2004 - 2009 Cadillac XLR: Service Bulletin: #15643A: Special Coverage - Airbag Light On - (Feb 2, 2017)

Subject:	15643A — Special Coverage Adjustment – Airbag Light On
Models:	2004 - 2009 Cadillac XLR
	2005 - 2013 Chevrolet Corvette

This bulletin has been revised to add accessory wiring harness part numbers to the Part Information section, update quantities of other parts required, and amend the Service Procedure to install the accessory wiring harness components. Please discard all copies of bulletin 15643.

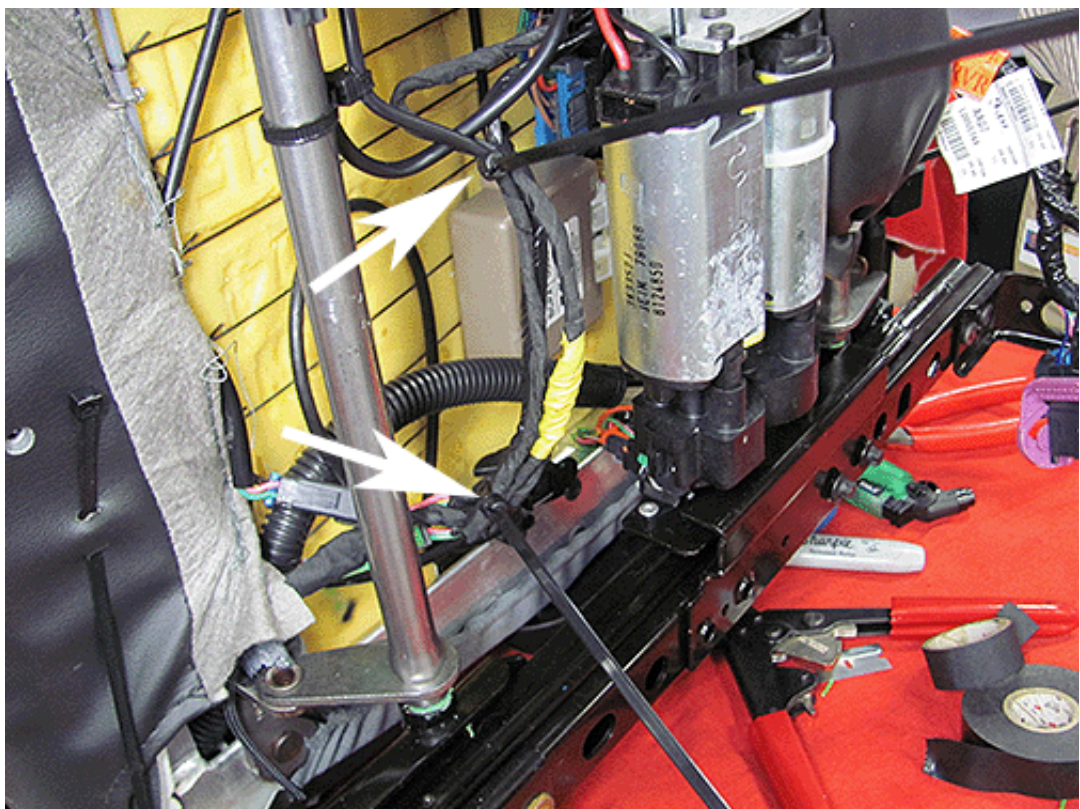
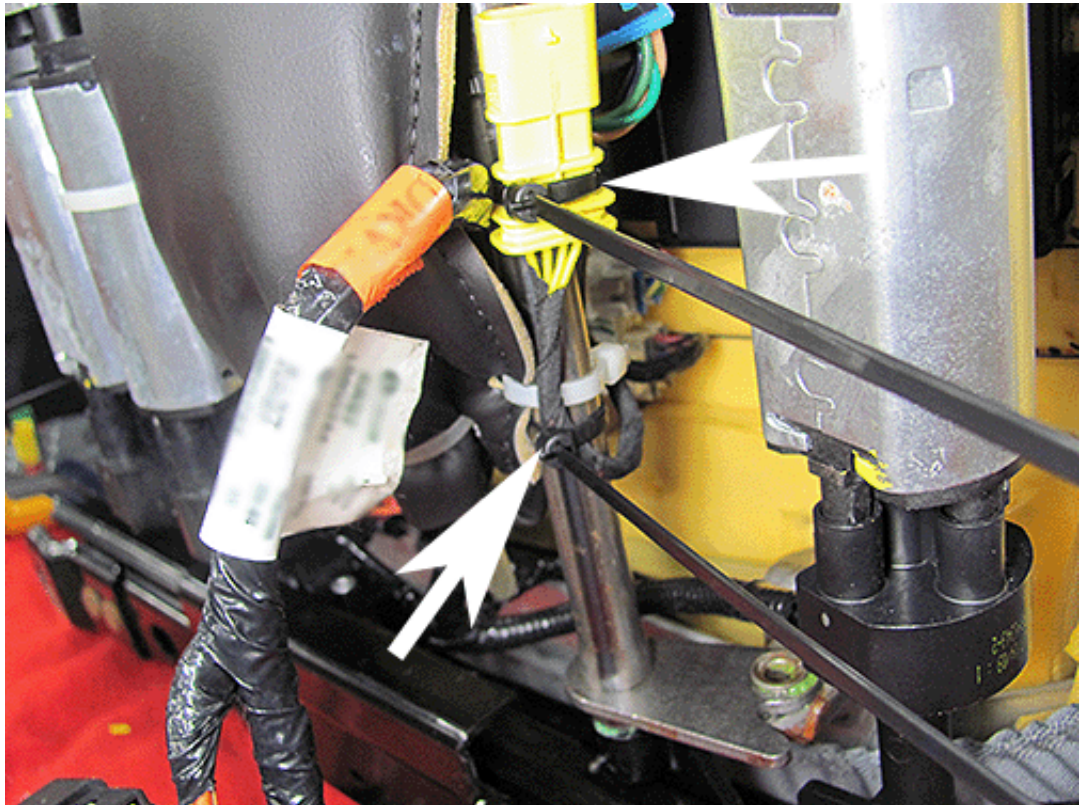
1. Route the harness to the front of the seat as shown.

2. Secure the harness to the rear of the seat as shown.

3. Secure the wire connector and harness to the FRONT seat cross bar using two cable ties.

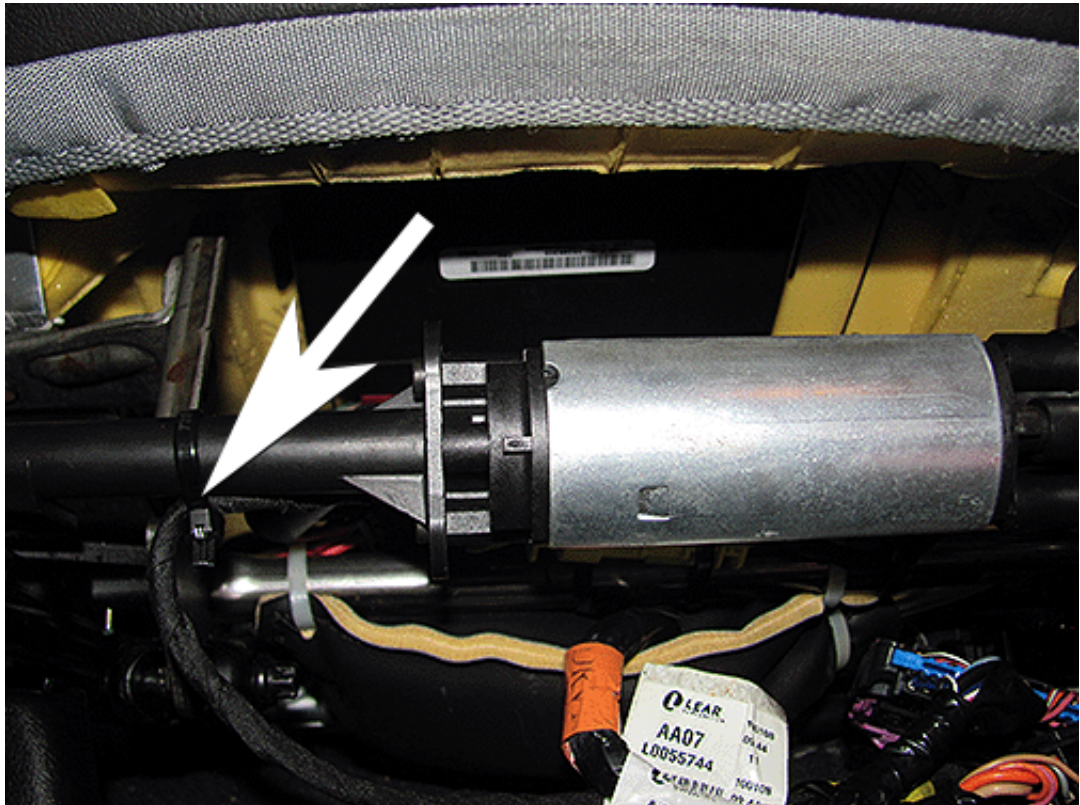
4. On the vehicle harness, pull the harness from under the carpet, to the front location as shown.

5. Measure 300mm (11.8 in) from the connector as shown.
6. Cut the four body side wires.
7. Strip off approximately 13 mm (1/2 in) of insulation from the wiring ends. Fold the wires.
8. Add one approximate 38 mm (1.5 in) section of heat shrink tube to each of the four wires.
9. On the service connector, strip off approximately 13 mm (1/2 in) of insulation from the wiring ends. Fold the wires.
10. Join the four wires in the order documented above.
11. Crimp a splice clip over the joined wires using Special Tool J-38125-8, nest F. Verify the crimp quality. Repeat this crimp process on all four wire connections.
12. Solder all four crimp and splice clips using the Ultratorch, part number J-38125-5, or another butane fueled soldering iron.
13. Center the heat shrink tube over all four splices and shrink/seal the heat shrink tube securely over the splice crimp and insulated wires.
